## AMHERST AVENUE BIKEWAY PROJECT

MANDATORY REFERRAL NO. MR2023008

- Staff recommends approval of the Mandatory Referral with comments
- Proposal is to construct two-way separated bike lanes along Amherst Avenue between Windham Lane and Arcola Avenue
- The Planning Board review of a Mandatory Referral is advisory

Figure 7: Typical Section between Prichard Road and Reddie Drive

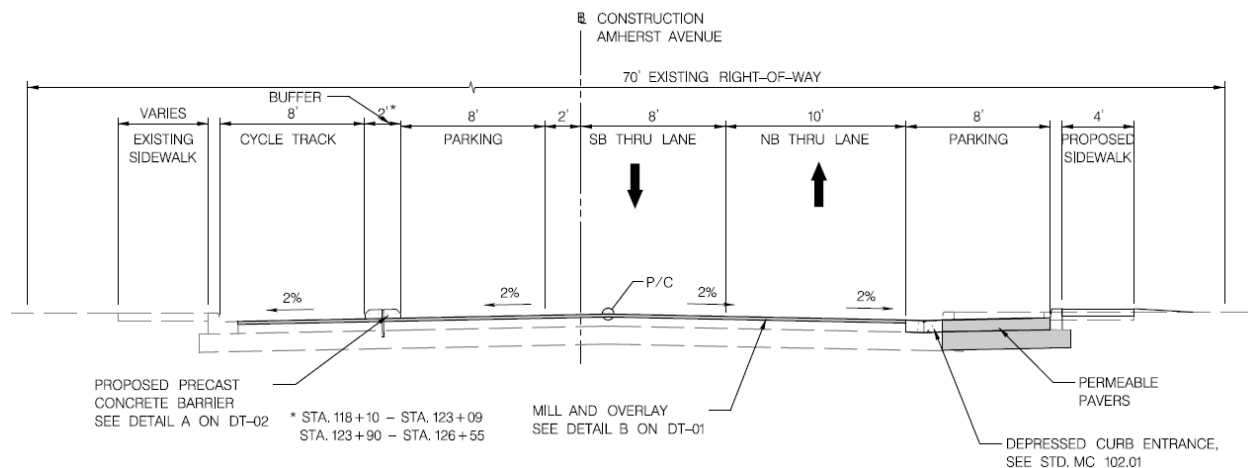
**1) Widen sidewalks to Complete Streets Design Guide minimum widths where curbs are being moved to provide the bikeway and maintain on-street parking.**

On the east side of Amherst Avenue between Prichard Road and Reddie Drive, the curb is proposed to be shifted to the east to accommodate the bikeway while preserving the two existing travel lanes and two existing parking lanes. The added space (six feet) outside the curb comes at the expense of the street buffer between the parking lane and the sidewalk. The sidewalk along the east side of the roadway is proposed to be four feet wide (Figure 7), which is narrower than the Complete Streets Design Guide minimum of six feet for a Neighborhood Street. A wider sidewalk could be provided within the existing right-of-way.

Figure 9: Examples of driveway aprons narrowing sidewalk space between Prichard Road and Reedie Drive (light grey lines reflect existing conditions, dark lines represent proposed changes)

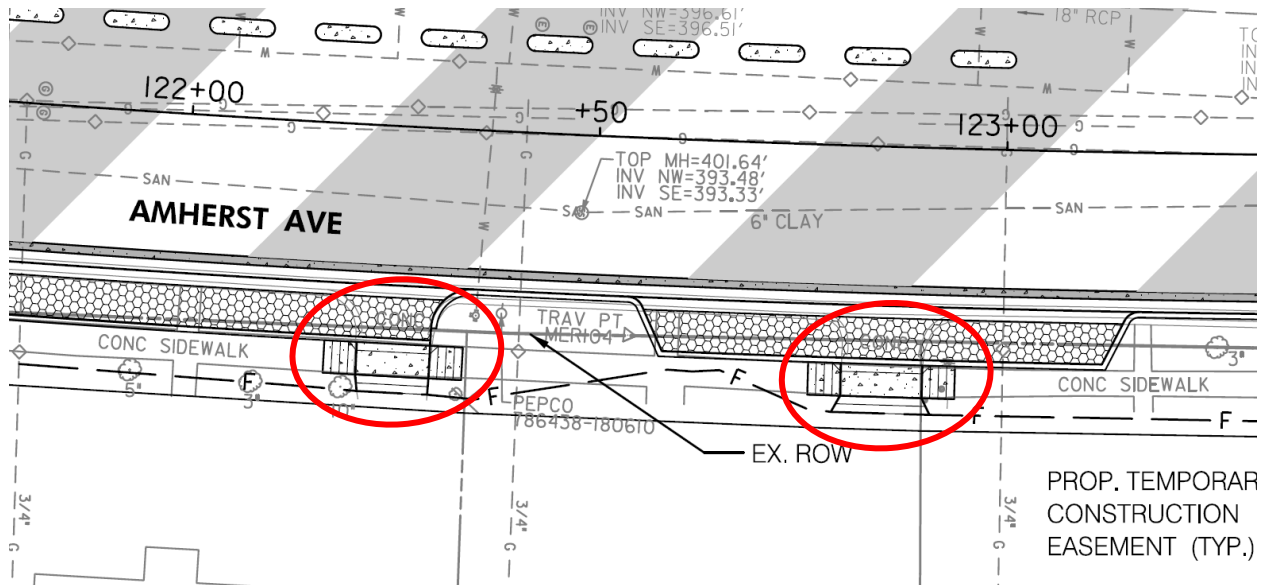
**3) Ensure that sidewalk crossings of driveways maintain sidewalk cross-slope and width.**

In the constrained block between Prichard Road and Reedie Drive, the sidewalk appears to narrow and potentially ramp down at driveway aprons (Figure 9). As these sidewalks are already narrow at four feet wide, the sidewalk width should be maintained across the driveways for accessibility reasons.

Figure 11: Diagonal curb ramp at southwest corner of Prichard Road and Amherst Avenue (light grey lines reflect existing conditions, dark lines represent proposed changes)

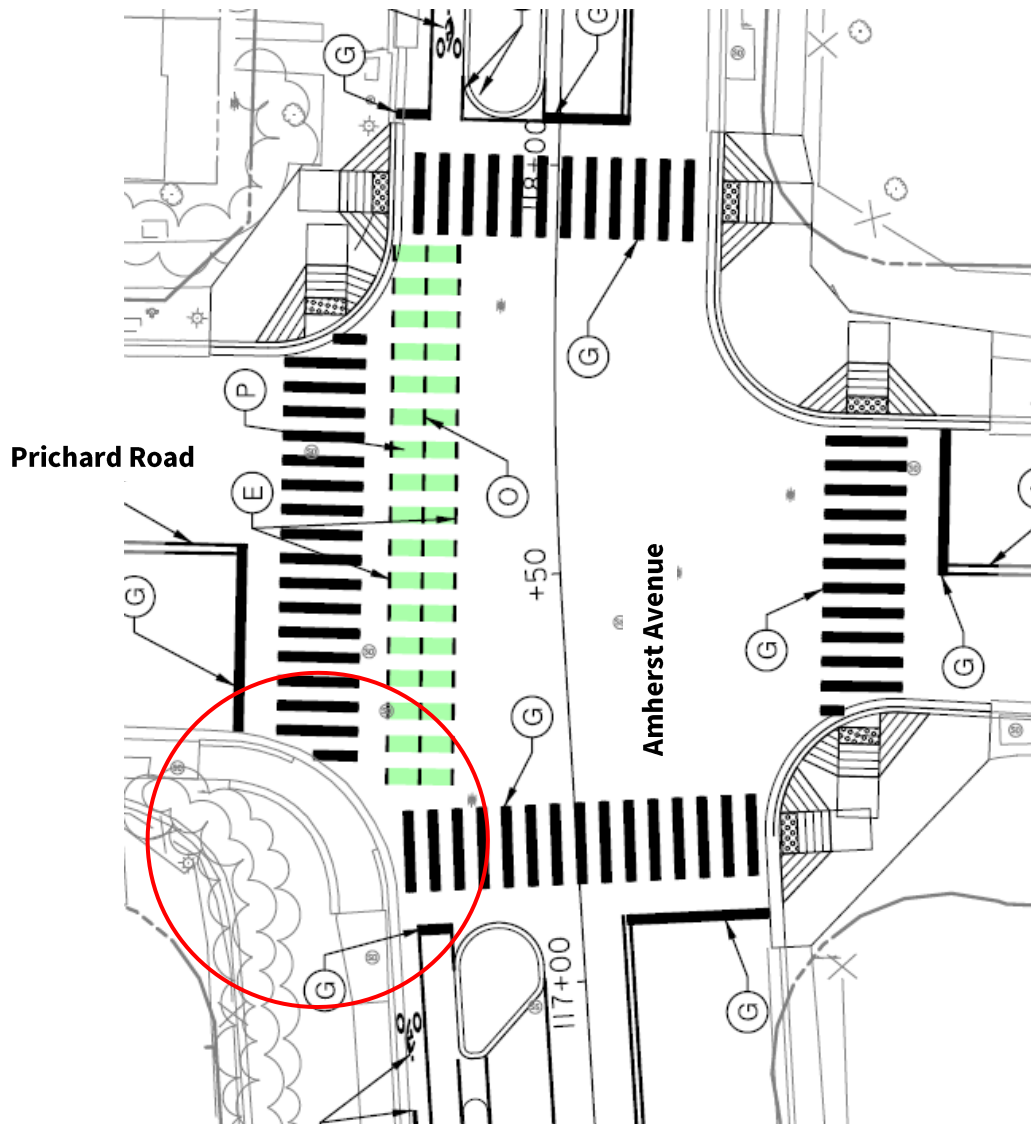
Unaligned curb ramps at the intersection of Amherst Avenue with Prichard Road and with Cobble Hill Terrace should be redesigned. For example, at the southwest corner of the Prichard Road intersection (see Figure 11), the circled corner has a single curb ramp that directs pedestrians into the middle of the street, rather than into one of the marked crosswalks. This is a safety issue because it puts pedestrians and motor vehicles in close contact. It's a particular issue for pedestrians with low or no vision because it is more difficult for these pedestrians to reorient themselves and proceed through the crosswalk.

Figure 12: Curb ramp locations at Bluebridge Avenue that should be widened (light grey lines reflect existing conditions, dark lines represent proposed changes)

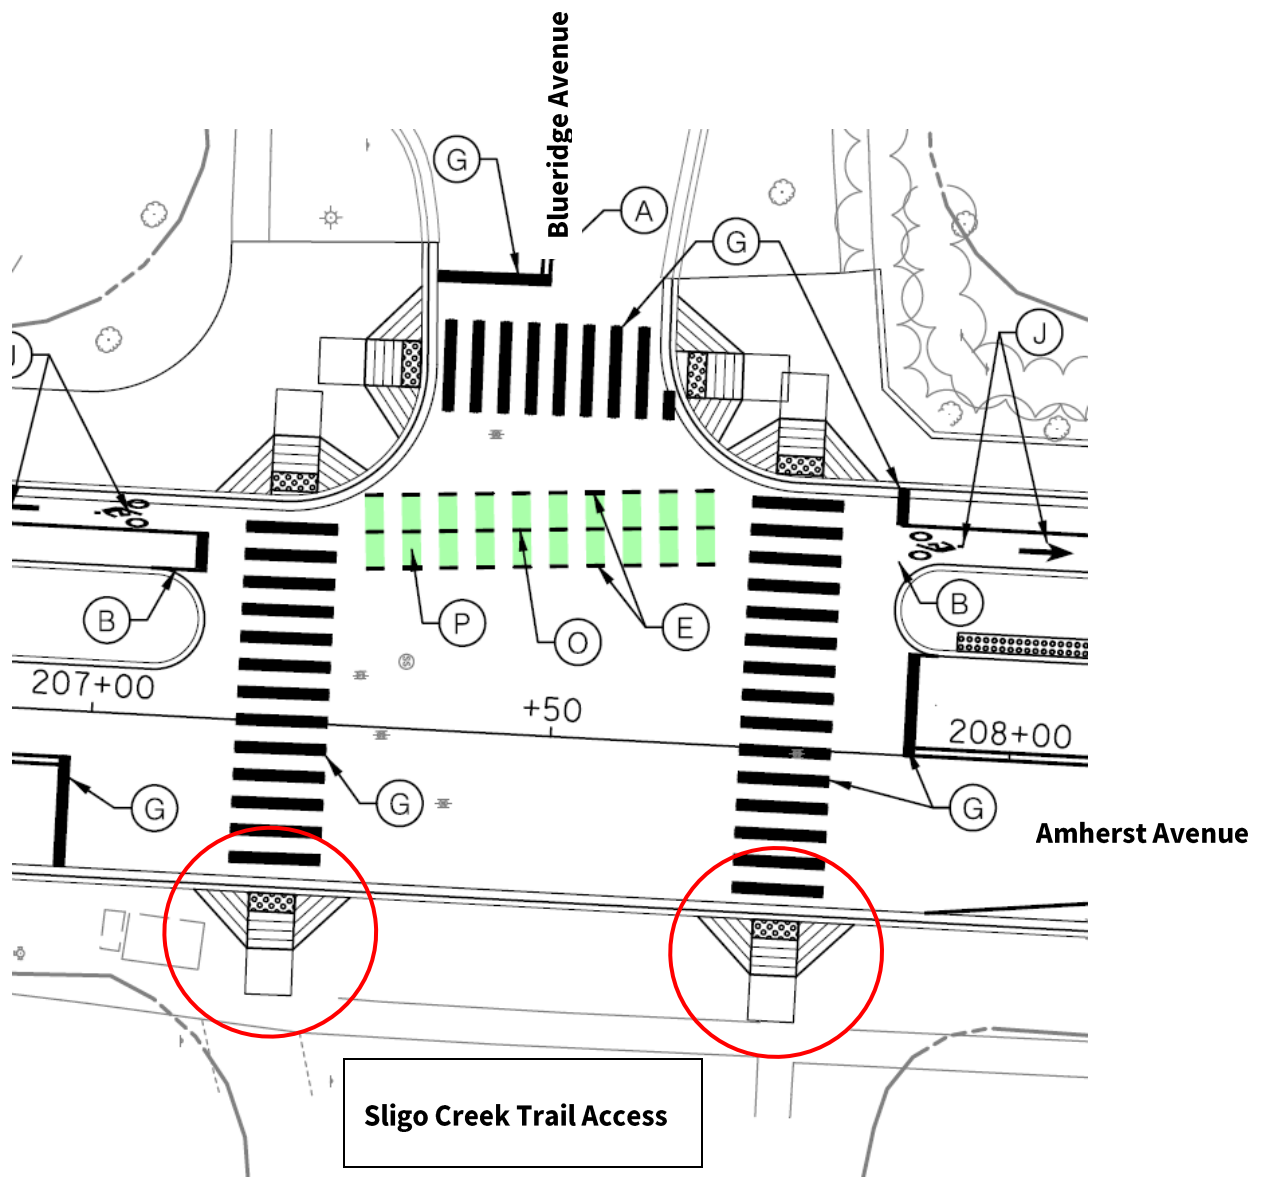
**5) Widen curb ramps on the east side of the Amherst Avenue/Blueridge Avenue intersection to shared use path width.**

Blueridge Avenue provides a connection between Amherst Avenue and the Sligo Creek Trail. Because this connection is a vital part of the regional bikeway network, the needs of bicyclists should be considered. The curb ramps highlighted at the bottom of Figure 12 should be widened to ten feet to accommodate pedestrians and bicyclists making this trail connection.

Figure 15: Break in concrete barrier for driveway (light grey lines reflect existing conditions, dark lines represent proposed changes)

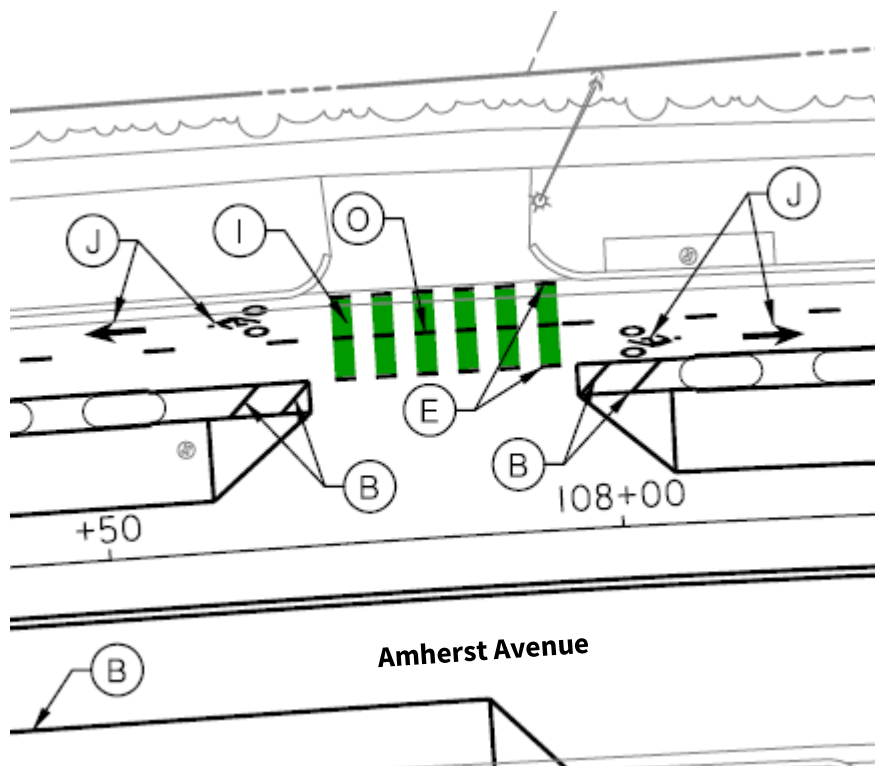
- **At Station 107+50**, the street buffer is interrupted to provide access to a driveway that does not exist (Figure 14, Figure 15) and encourages motorists to illegally park in the bike lanes. If this property redevelops in the future, the curb cut and break in the street buffer could be added.

Figure 16: Driveway at Station 132+50 (light grey lines reflect existing conditions, dark lines represent proposed changes, red boxes identify opportunities to extend concrete protection in the bikeway buffer)

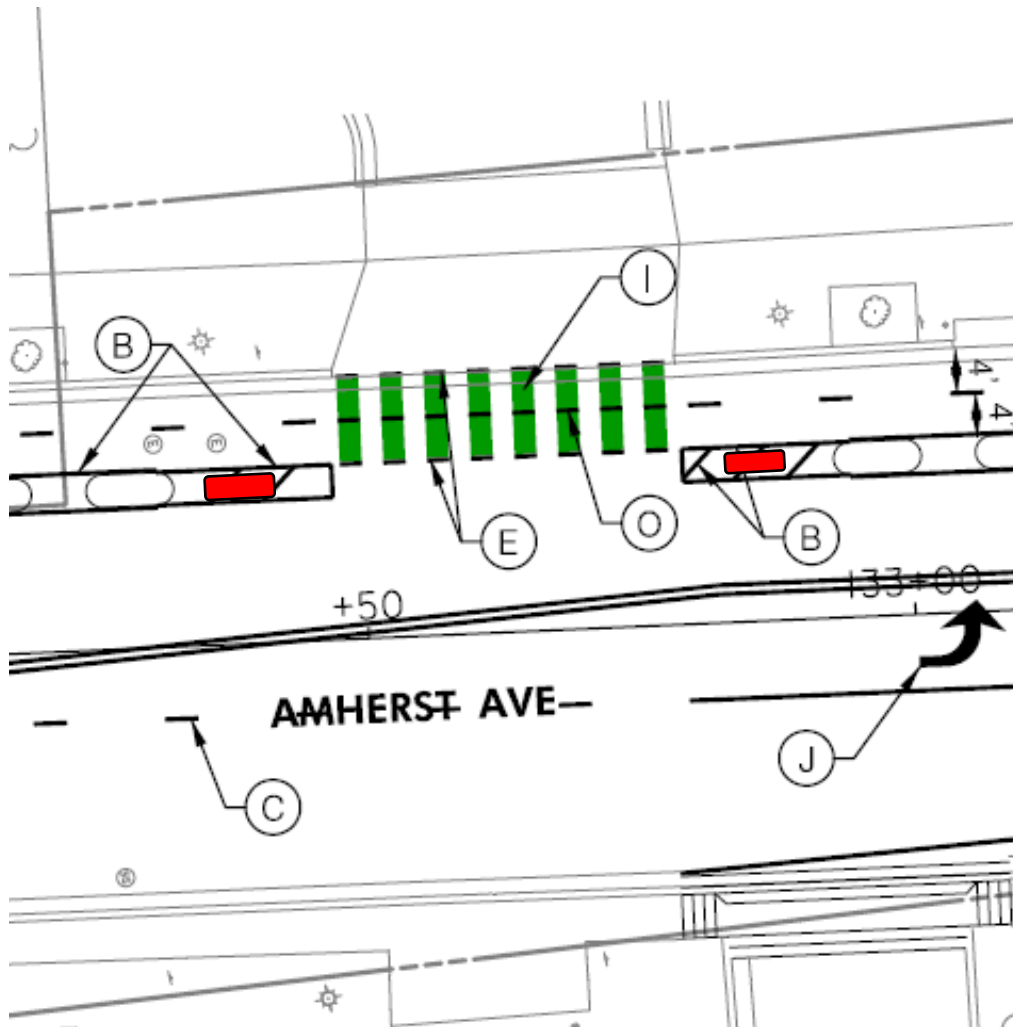
- Where possible, extend the street buffer closer to driveway entrances to tighten the turning radius, which will help achieve the 10-mph maximum turning speed defined in the Complete Streets Design Guide. Locations where the street buffer could potentially be lengthened are **Stations 110+75, Station 113+50, Station 131+50, Station 132+50, and Stations 219+75**). An example is shown in Figure 16.

Figure 18: Station 125+50 plan view (light grey lines reflect existing conditions, dark lines represent proposed changes)

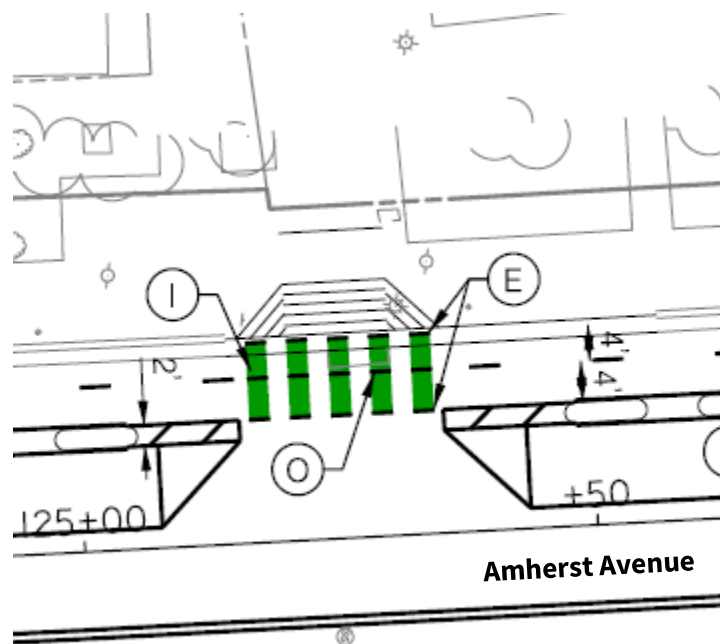
- At **Station 125+50**, the design shows a gap in the street buffer to enable access to a proposed curb ramp connecting to a sidewalk into a townhouse community, as shown in Figure 17 and Figure 18. This curb ramp does not exist today, and it is not clear why this curb ramp is needed as it would create a midblock crossing that is only about 140 feet from the nearest intersection. It should be removed and replaced with a concrete street buffer.

*Figure 19: A gap in the street buffer at Station 115+00 is provided for access to a fire hydrant (light grey lines reflect existing conditions, dark lines represent proposed changes, the red arrow indicates where the fire hydrant should be moved)*

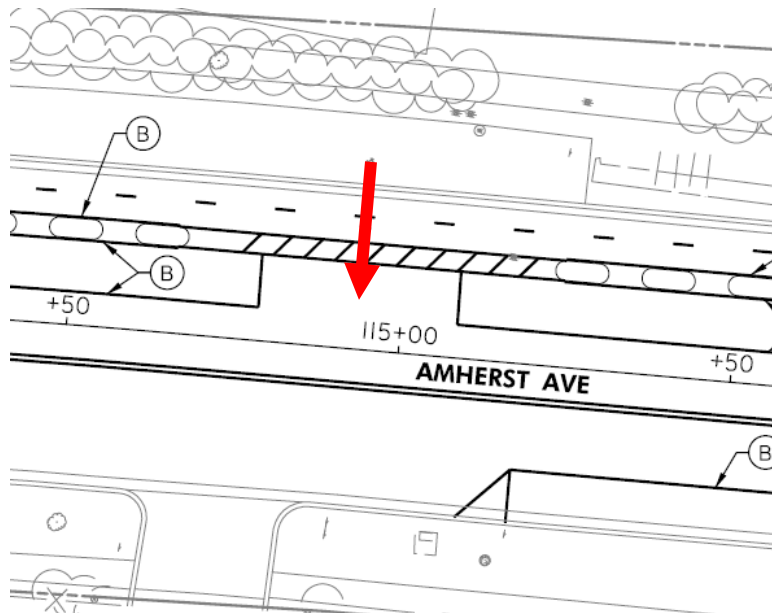
At **Station 115+00**, a gap in the on-street parking and concrete street buffer is proposed to provide access to a fire hydrant on the curb side (Figure 19). This break in the concrete buffer creates an opportunity for motorists to illegally park in the bike lanes. The fire hydrant should be relocated into the parking lane as part of a curb extension. If this is not possible, other design alternatives should be considered that make illegal parking and encroachment into the bikeway impossible.

Figure 21: Amherst Avenue intersection with Windham Lane (light grey lines reflect existing conditions, dark lines represent proposed changes)

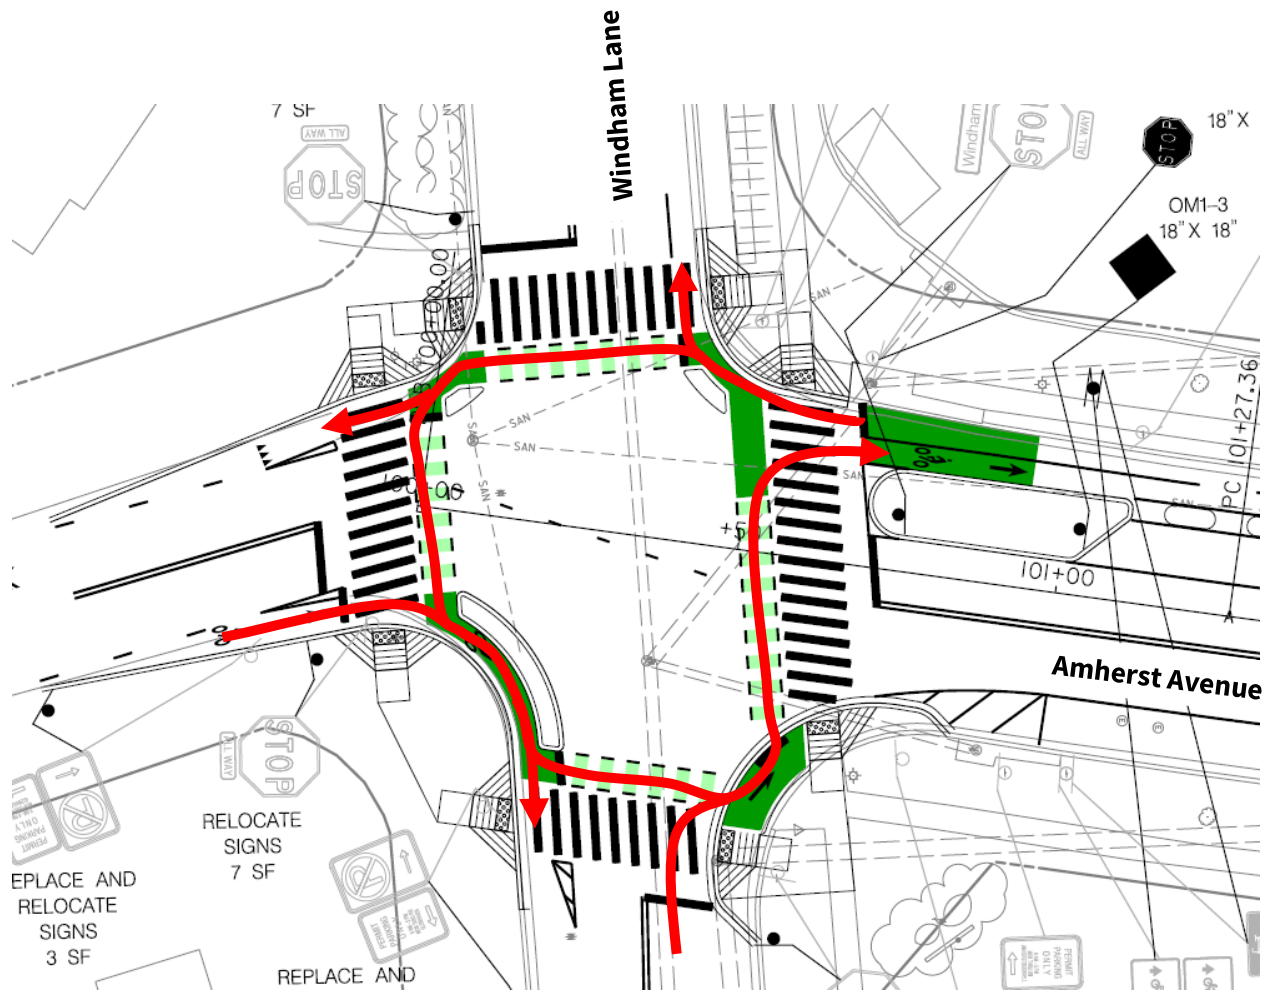
The southern terminus of the Amherst Avenue Bikeway at Windham Lane (Figure 21) requires bicyclists to travel out of their way when transitioning to and from the bikeway.

While protected intersections are beneficial in most instances, the unique nature of this intersection makes a different approach worth considering. This is because requiring bicyclists to divert around the entire intersection and yield the right-of-way multiple times will likely result in poor compliance by bicyclists. Instead, the design should do everything possible to improve visibility and tighten turning radii while allowing bicyclists to travel freely, as shown in Figure 22. Designers should consider providing cross-bike markings (shown in yellow below) for bicyclists traveling north and south to make it easier for drivers to understand potential bicycle movements. Additionally, the separate

bicycle space created in the northbound direction of Amherst Avenue south of Windham Lane should be removed, and bicyclists should be encouraged to queue like other vehicles at this intersection.
